SUBMITTAL OF DANGEROUS WASTE PERMIT PACKAGE PTF-009, REVISION 2, FOR THE PRETREATMENT FACILITY

Permit Package PTF-009, Revision 2, Supplemental
Permit Package for FRP-VSL-00002A, FRP-VSL-00002B,
FRP-VSL-00002C, and FRP-VSL-00002D Vessel Alterations

Supplemental Permit Package PTF-009, Rev. 2 Description
Vessel Alterations to FRP-VSL-00002A/B/C/D

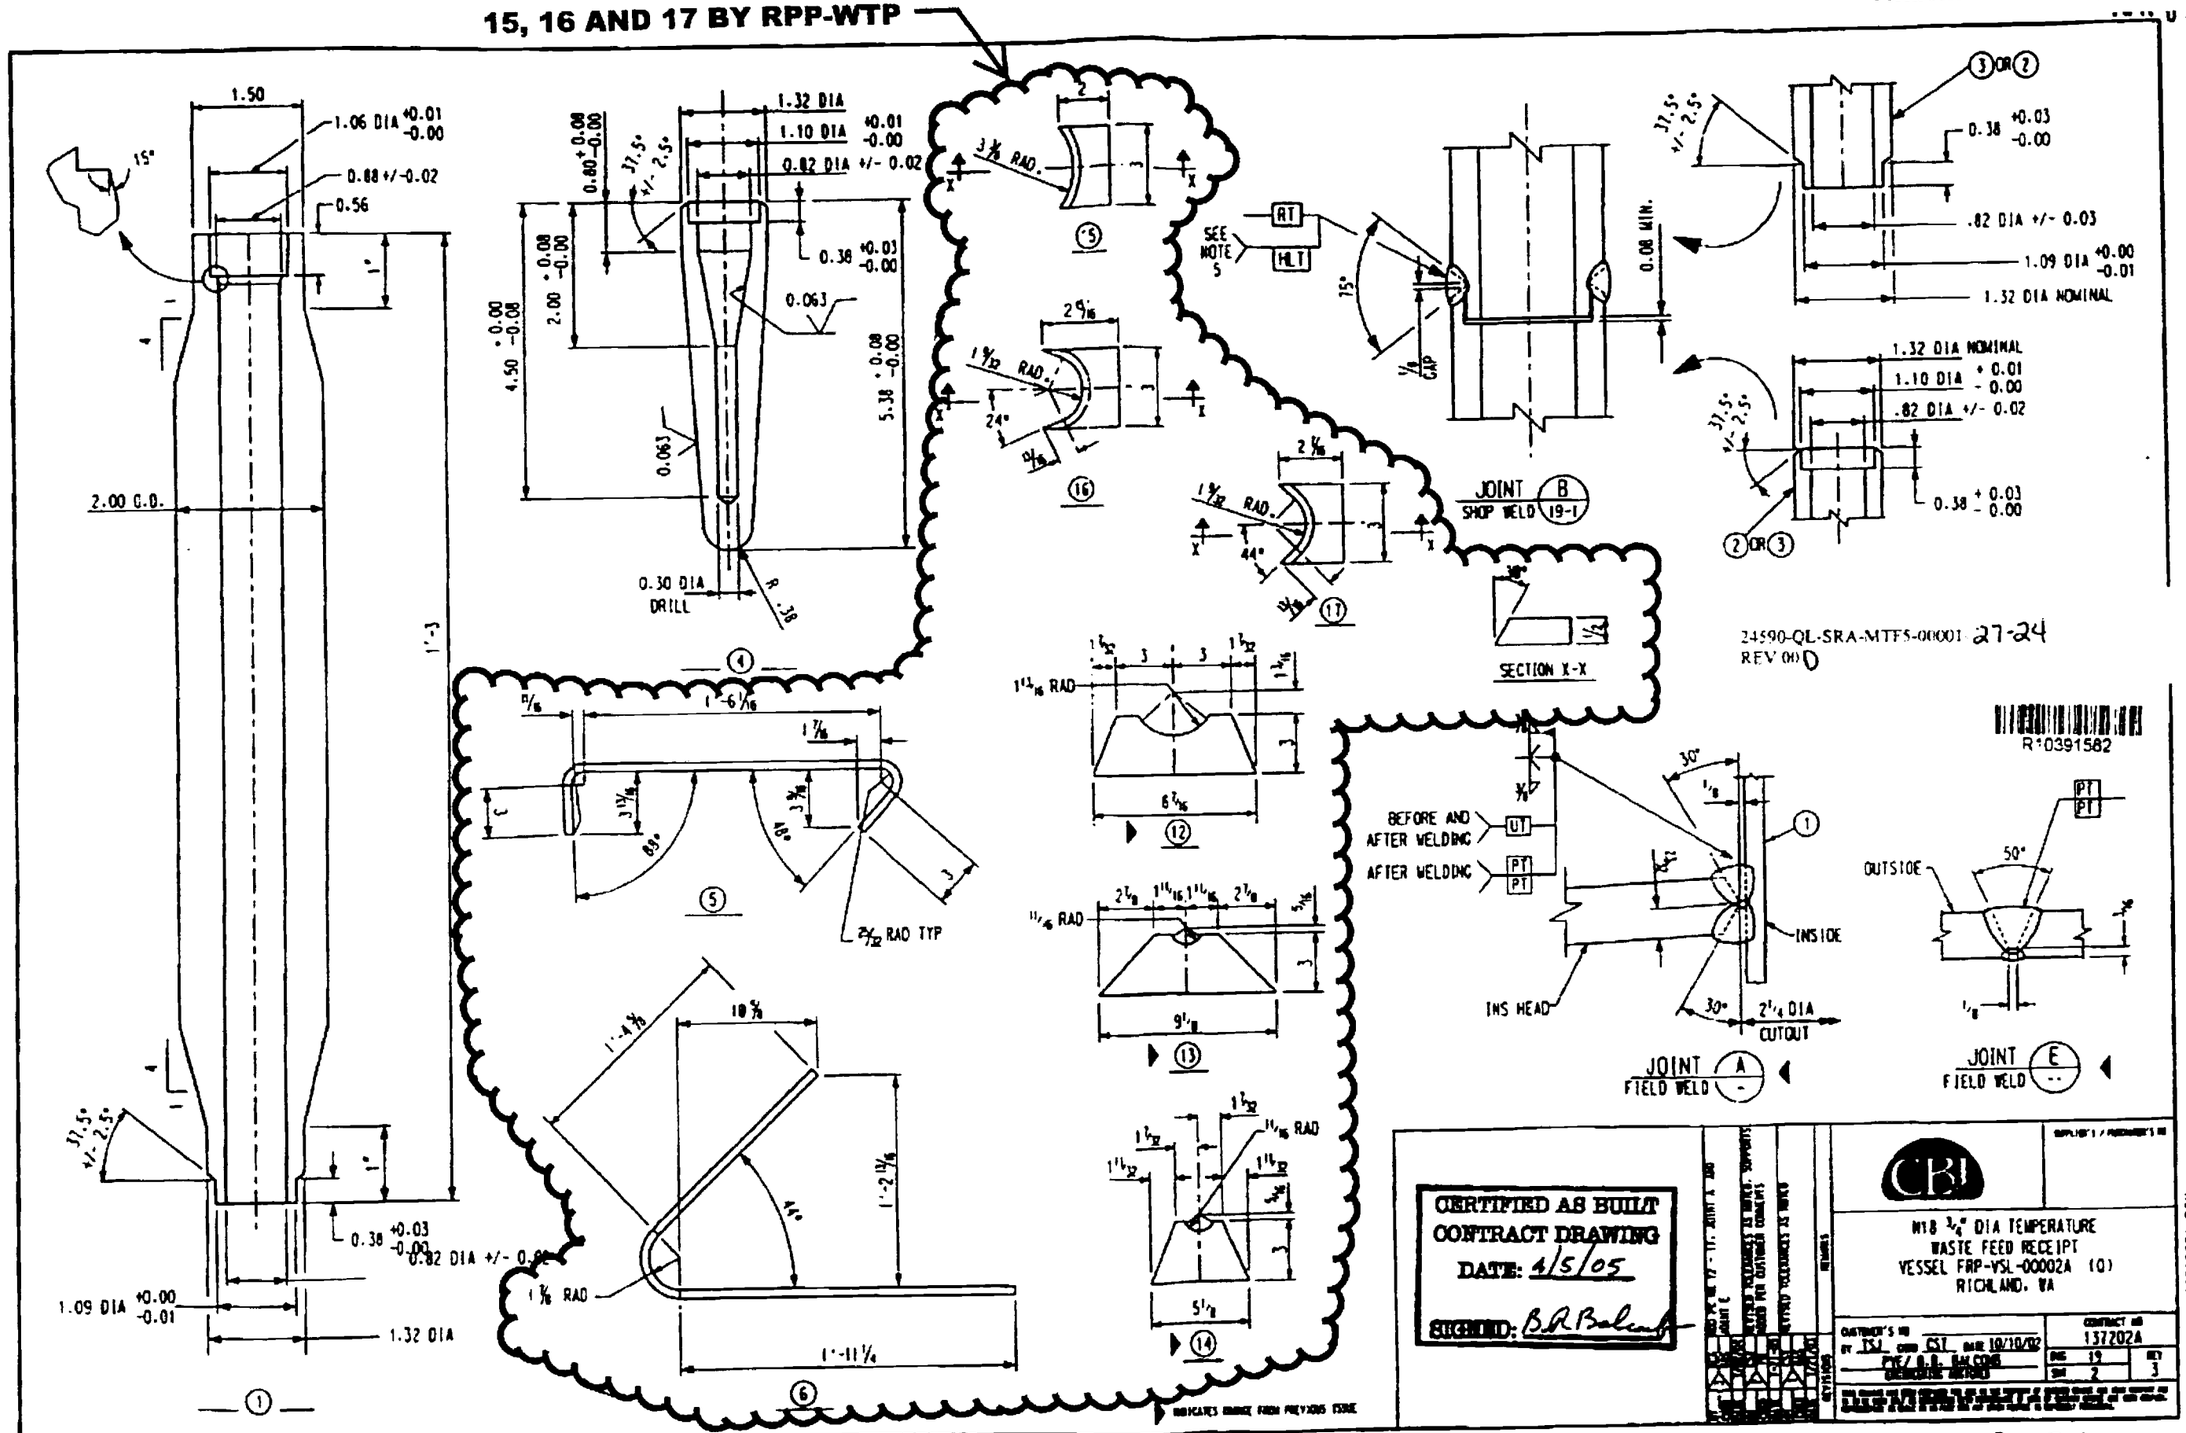
DELETE ITEMS 5, 6, 12, 13, 14, 15, 16 AND 17 BY RPP-WTP

WASH RING PLAN VIEW
N56-N62

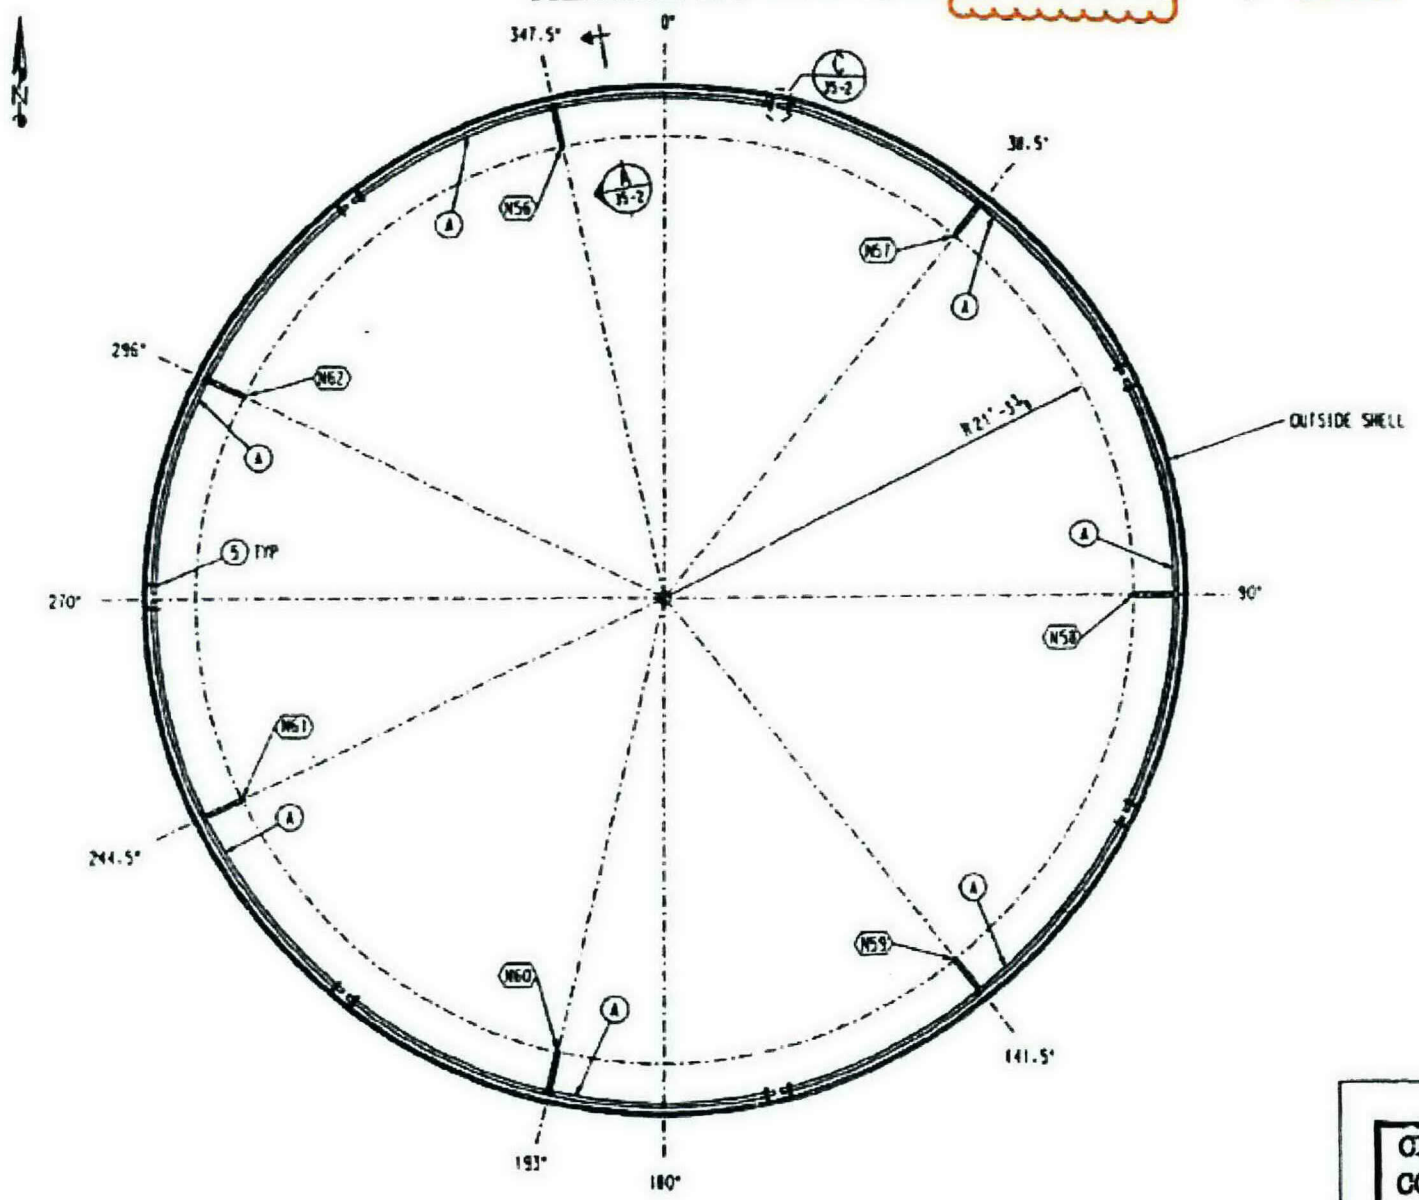
REVISE BY RPP-WTP ON HOLD 160S

ELEVATION

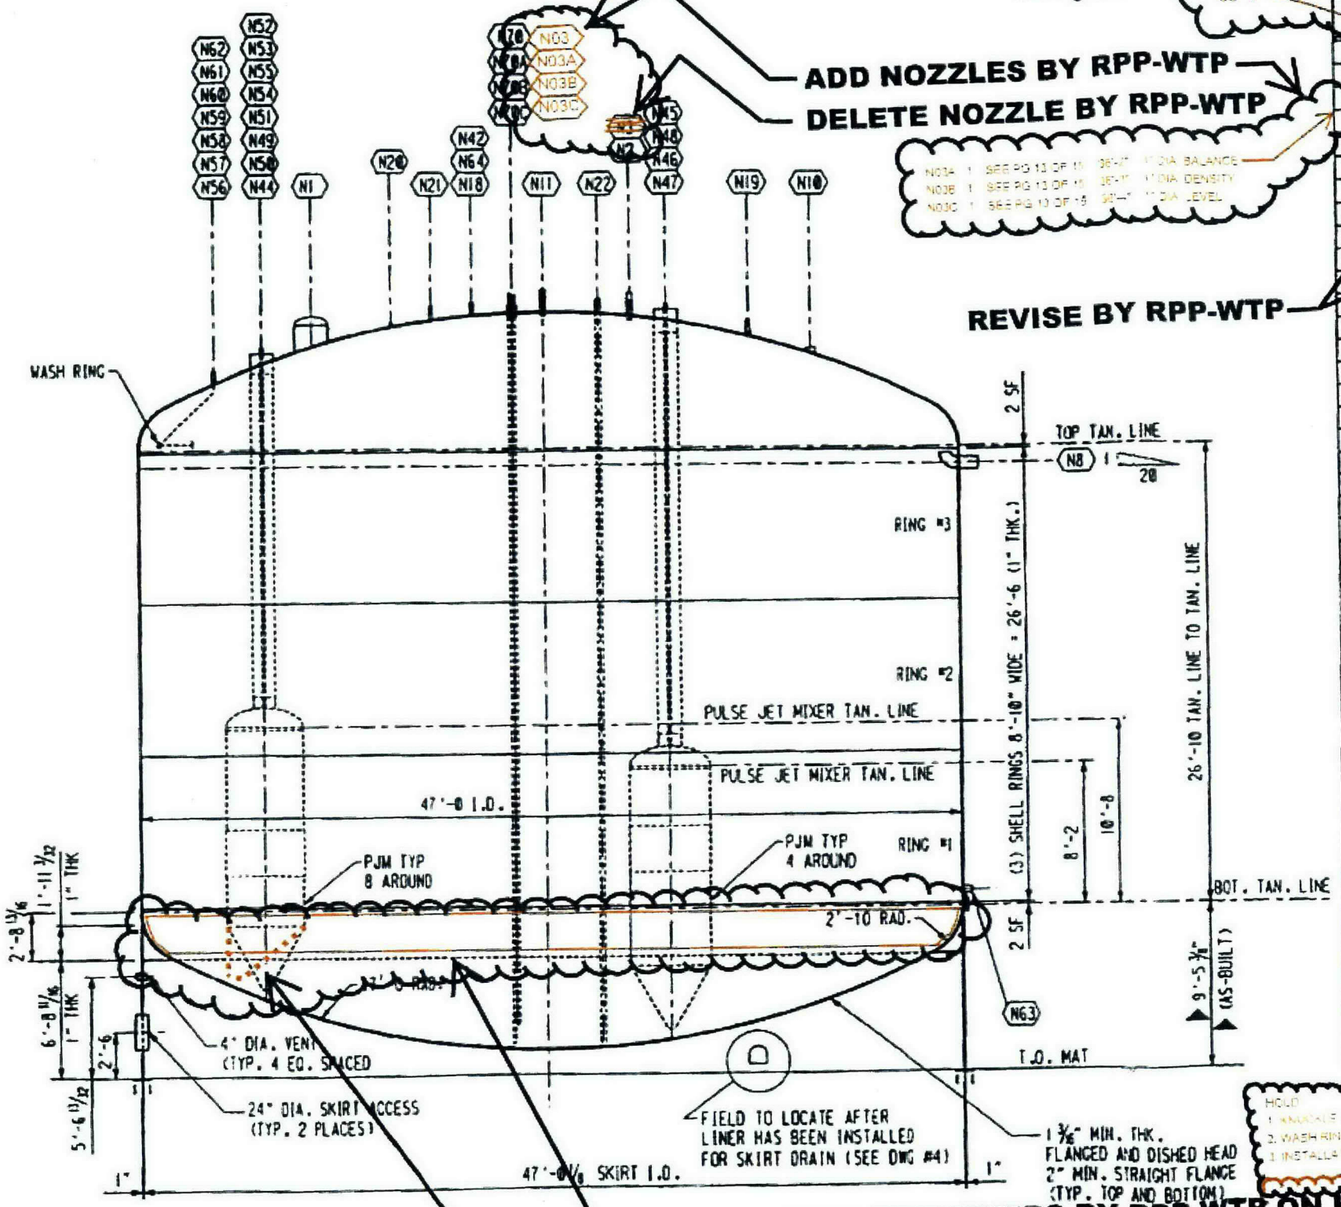
REVISE BY RPP-WTP

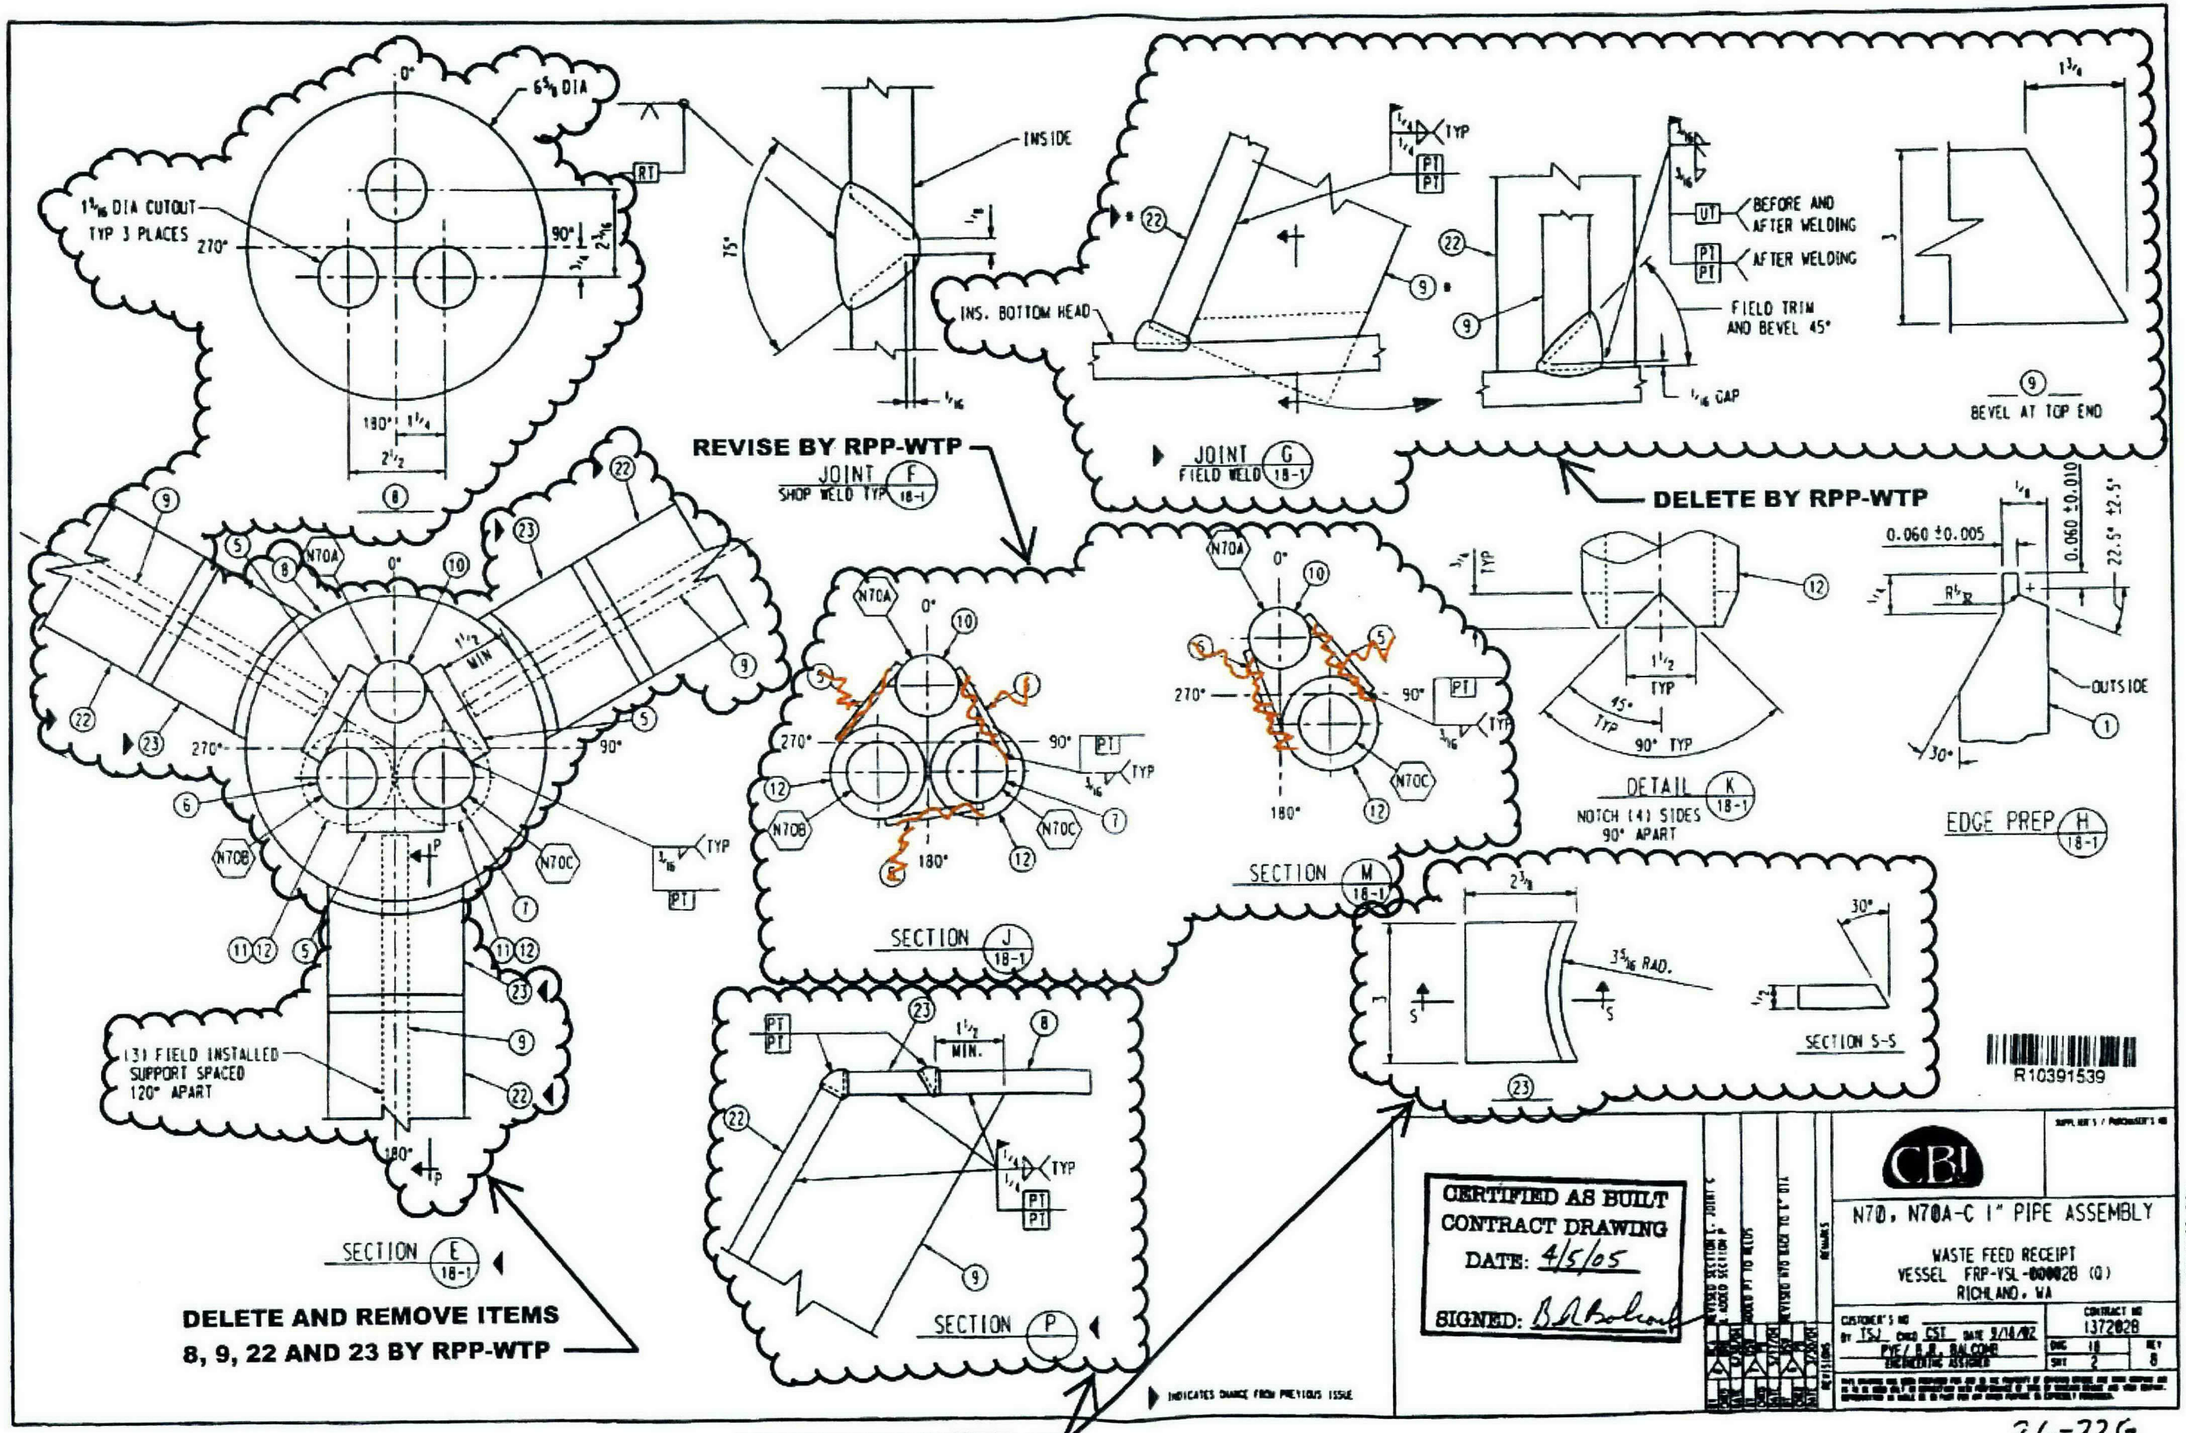
REVISE BY RPP-WTP
DELETE BY RPP-WTP
DELETE AND REMOVE ITEMS 8, 9, 22 AND 23 BY RPP-WTP
DELETE BY RPP-WTP
JOINT F SHOP WELD TYP 18-1
JOINT G FIELD WELD 18-1
DETAIL K 18-1 NOTCH (4) SIDES 90° APART
EDGE PREP H 18-1
SECTION E 18-1
SECTION J 18-1
SECTION M 18-1
SECTION P
SECTION S-S
(3) FIELD INSTALLED SUPPORT SPACED 120° APART
1 9/16 DIA CUTOUT TYP 3 PLACES
6 5/8 DIA
INSIDE
INS. BOTTOM HEAD
BEFORE AND AFTER WELDING
AFTER WELDING
FIELD TRIM AND BEVEL 45°
1/16 GAP
BEVEL AT TOP END
OUTSIDE
0.060 ±0.005
0.060 ±0.010
22.5° ±2.5°
3 5/16 RAD.
R10391539
CERTIFIED AS BUILT CONTRACT DRAWING
DATE: 4/5/05
SIGNED:
CBI
N70, N70A-C 1" PIPE ASSEMBLY
WASTE FEED RECEIPT
VESSEL FRP-VSL-00002B (Q)
RICHLAND, WA
CONTRACT NO 1372028
INDICATES CHANGE FROM PREVIOUS ISSUE
29218028.DGN
